# AGENDA

January 2, 2025 Platting Board Hearing Packet 2 of 69

#### STAFF REVIEW AND RECOMMENDATIONS PUBLIC HEARING JANUARY 2, 2025

PRELIMINARY PLAT:	CAMELOT	
LEGAL DESCRIPTION:	SEC 27, T18N, R03W, SEWARD MERID	IAN AK
PETITIONERS:	CRAFTY ENTERPRISES LLC	
SURVEYOR/ENGINEER:	R & K LAND SURVEYING / HOLLER E	NGINEERING
ACRES: 9.96 <u>+</u>	PARCELS: 9	
REVIEWED BY:	MATTHEW GODDARD	CASE #: 2024-129

Agenda Copy

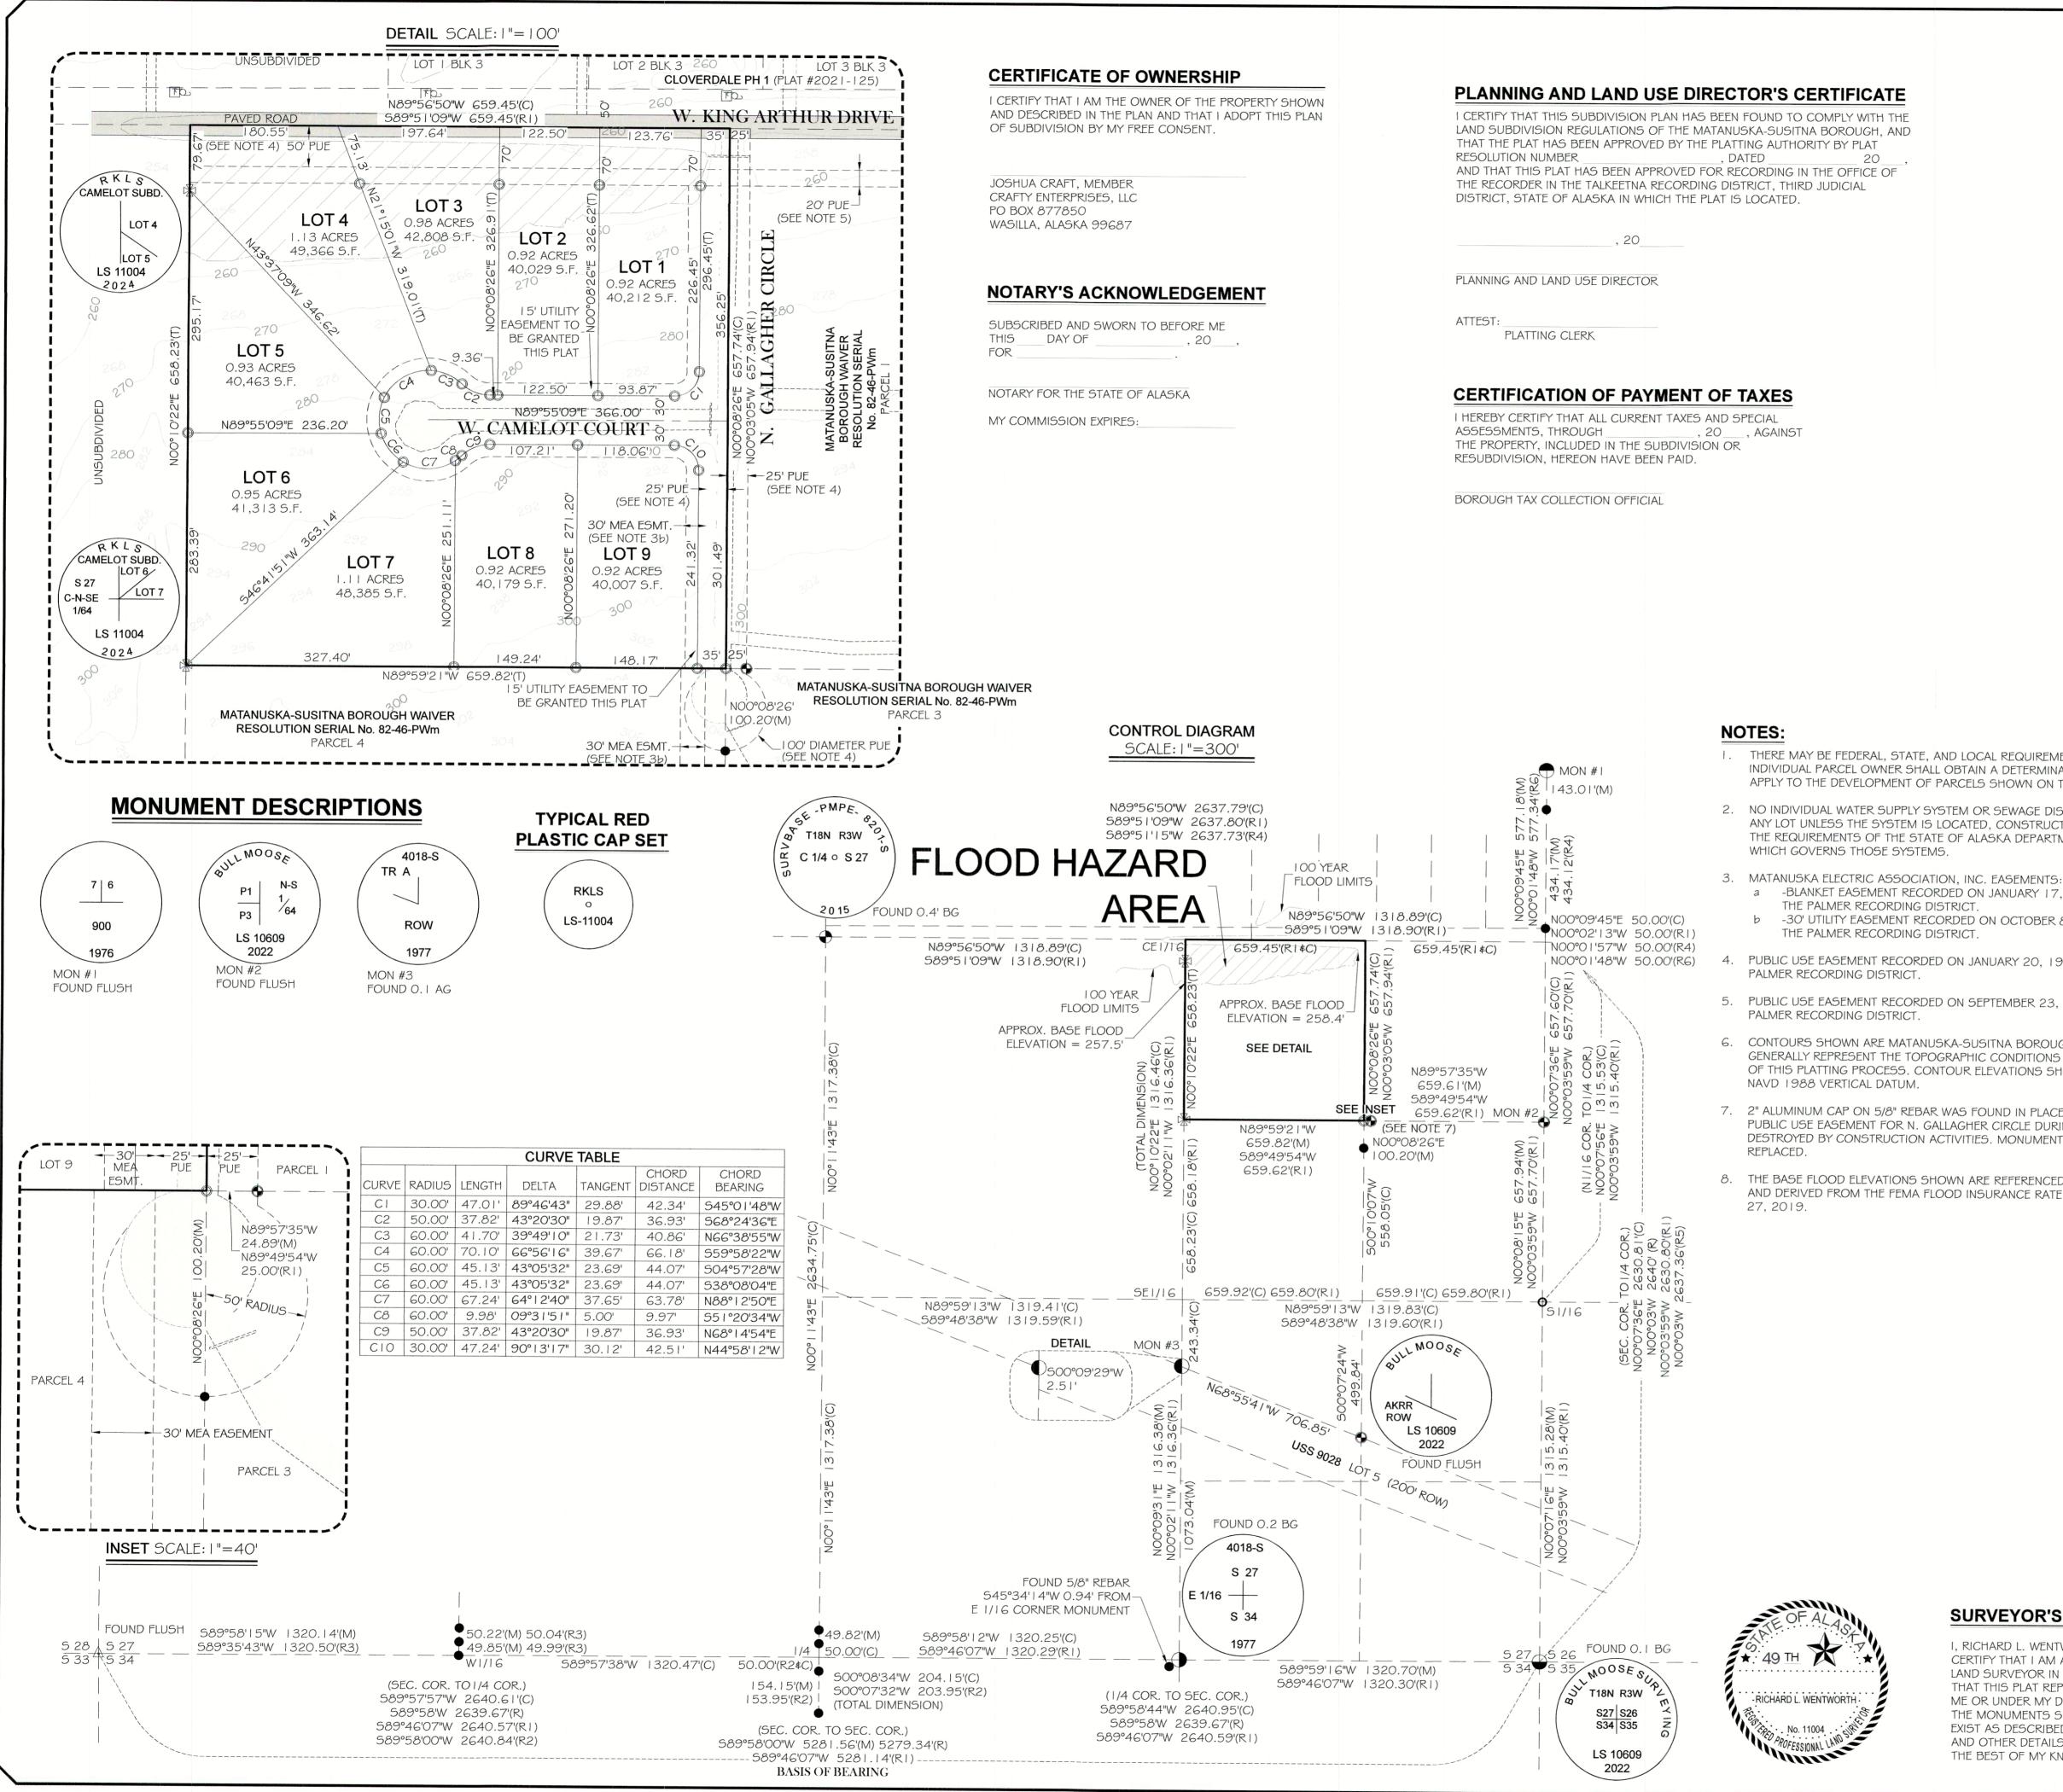
Department of Public Works Operations & Maintenance (**Exhibit Page 21**) Coordinate with the City of Houston for road approval and access onto King Arthur Drive (**Recommendation #4**).

Planning Division (**Exhibit Page 22**) notes that this parcel has a designated Special Flood Hazard Area (SFHA) identified on it and therefore required under MSB 17.29 to meet the development and permitting requirements for encroaching into this SFHA before beginning any work. This includes clearing, grading, excavation, fill, and storage of equipment or material and could require engineering.

Platting staff notes that the road construction as proposed will take place outside of the Special Flood Hazard Area. As such, a permit should not be required for the subdivision process. Should the developer need to work within the SFHA, a permit would be required at that time.

- 3. Pay postage and advertising fees.
- 4. Construct the access road and cul-de-sac to residential standard according to the 2022 Subdivision Construction Manual (SCM):

- a) Submit drainage report and other construction plans to City of Houston Public Works Department per SCM F01.2;
  - b) Arrange preconstruction conference with City of Houston Public Works per SCM F01.3;
